INALWAYS ELECTRONICS INC.

產品變更通知 Product Change Notice

No. 20240712

Inalways P/N(華瑋/力瑋)料號 :0708-1-CQF-UBK/0708-1-C.Fxx-H-UBK/0708-1-FQF-UBK/
0708-1-CWF-UBK/0708-1-FWF-UBK/0708-1-FNF-UBK/0708-1-CNF-UBK

Before (變更前):

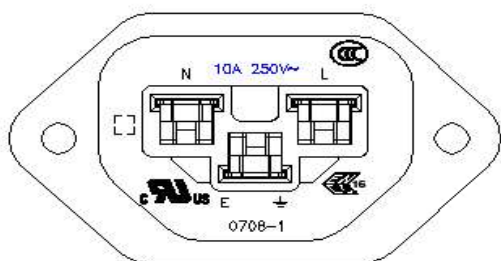
- UL 测试升级，由原来 10A 250V~ 升级为 15A 250V~。
UL test upgrade, from the original 10A 250V ~ upgrade to 15A 250V ~。
- 變更後的圖紙如附件
The drawings are as attached files.
- 變更刻字後的出貨將於 2024/10/01
The marking changes shipment will be started from 2024/10/01
